Re: **TRI-COUNTY COUNCIL / SHORE TRANSIT BUS MAINTENANCE FACILITY**
PHASE II
Salisbury, Maryland
2009145.00

ADDENDUM SIX

REVISED DETAIL 5/A502

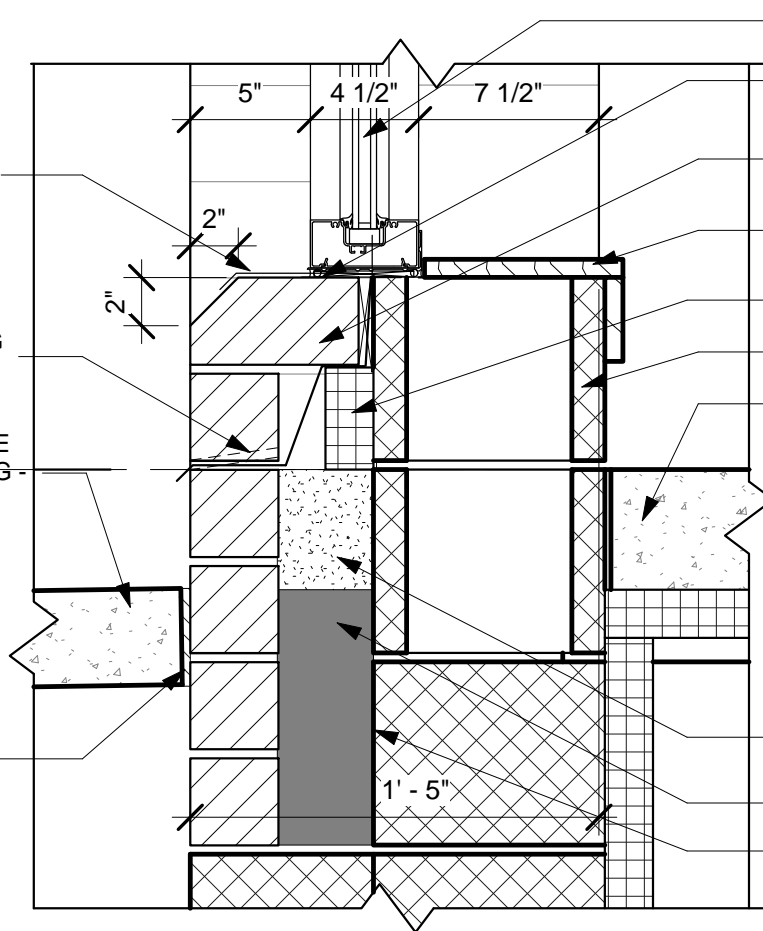
- a. REPLACE detail 4/A502 with Sketch MTA-SK-7 dated 02/28/12 issued via this addendum
- b. REPLACE detail 5/A502 with Sketch MTA-SK-8 dated 02/28/12 issued via this addendum
- c. REPLACE detail 8/A502 with Sketch MTA-SK-9 dated 02/28/12 issued via this addendum

ALUMINUM SILL CAP IN
BED OF SEALANT
CONTINUOUS FLASHING
WITH WEEPS
CONC. SIDEWALK SLOPE
MIN. 1/8" FROM BUILDING -
SEE CIVIL DRAWINGS

ALUMINUM STOREFRONT
WINDOW
BACKER ROD & SEALANT
BOTH SIDES
SPECIAL SHAPED BRICK
HEADER AT SILL TYP.
SOLID SURFACE SILL AND
APRON
2" RIGID INSULATION
8" EPOXY PAINTED CMU
CONC. SLAB - SEE STRUCT.
FINISH FL. ELEV. 50.26
0' - 0"
FILL CAVITY W/ AGGREGATE
BTWN FLASHING AND GRADE
GROUT CAVITY BELOW GRADE
DAMPPROOFING
